**To:** Grace Macdonald  
**From:** Mark Irish  
**Date:** 25 February 2022  
**Subject:** Horsley Logistics Park - Jalco SSDA  
Response to EPA Request for Additional Information

**At:** ESR  
**At:** SLR Consulting Australia Pty Ltd  
**Ref:** 610.19360-M07-v1.0 Jalco EPA  
Response.docx

Figure 1 Lot 201 Warehouse 1 Internal Building Plan and Noise Sources (Updated Report Figure 2)

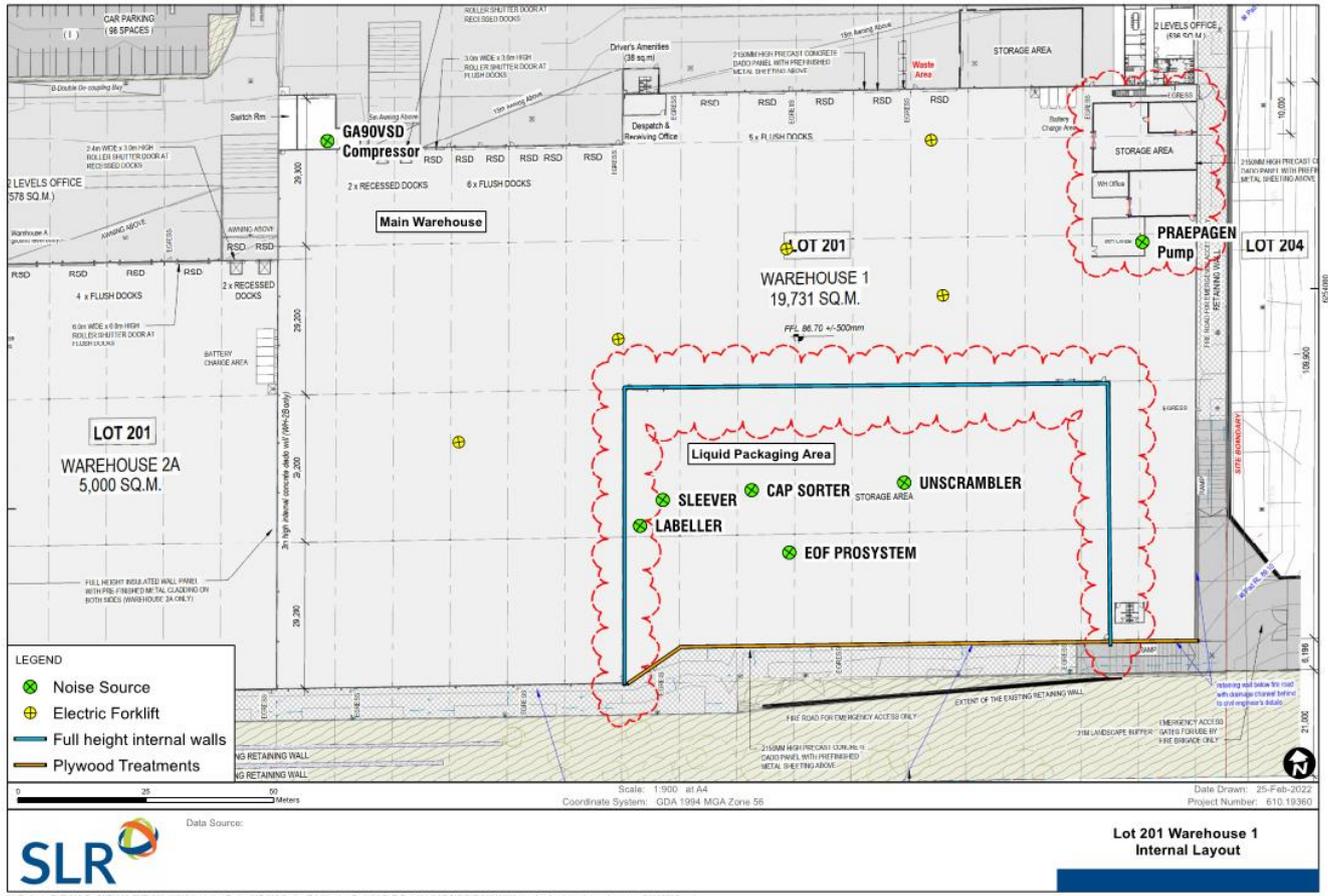
*The map of the site layout and noise sources in NIA Figure 2 is not clear, does not contain labels that identify the sources, is of poor image quality and is difficult to read and understand.*

*There are a number of noise sources listed in Section 6, however NIA Figure 2 and other figures in the NIA are not adequate such that EPA can clearly identify where noise sources are located. NIA Table 4 also lists a number of area sources used in the predictions, however EPA have not been able to identify the location and size of these area sources from any map or image in the NIA. The site layout does not clearly identify the location of openings or doors in the walls or roof.*

*EPA recommends a revised site layout is provided which includes labels and the source type at an appropriate resolution so that it can be read and understood. The site layout must include all noise sources modelled including point, area and line source types and a label to identify which item of plant or activity they represent. It should also include all details pertinent to an acoustic calculation, such as doors and openings (including penetrations for mechanical ventilation) in a building where noise breakouts.*

The internal and external layouts in Figure 2 and Figure 3 of the report have been updated to confirm the locations of internal and external sources associated with the Jalco operations as shown below.

**Figure 3** Location of noise breakout mitigation measures

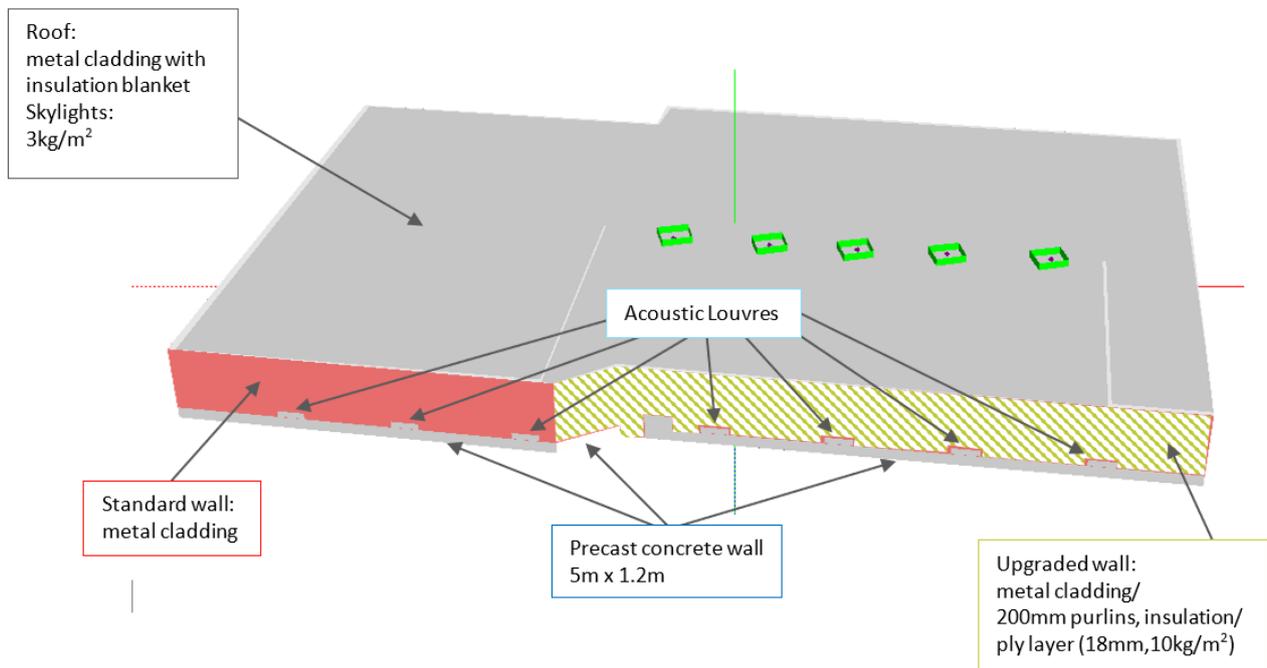
*NIA Chapter 6.3 has included a recommendation for the following:*

*“Acoustic louvres to the Southern elevation of Liquid Packaging Area, specified as NAP 300 H-line, Fantech SBL1 or equivalent.”*

*The NIA does not provide the location of this measure, nor is it clear what this control measure is for.*

*EPA recommends that clarification is provided as to the location of the recommended louvres and the reason they have been recommended.*

The acoustic louvres have been specified in the southern facade as ventilation openings were required to be included as part of the Odour assessment, along with fans located on the roof as shown in Figure 3 of the report.

The location of the louvres is indicated in **Figure 3** below.
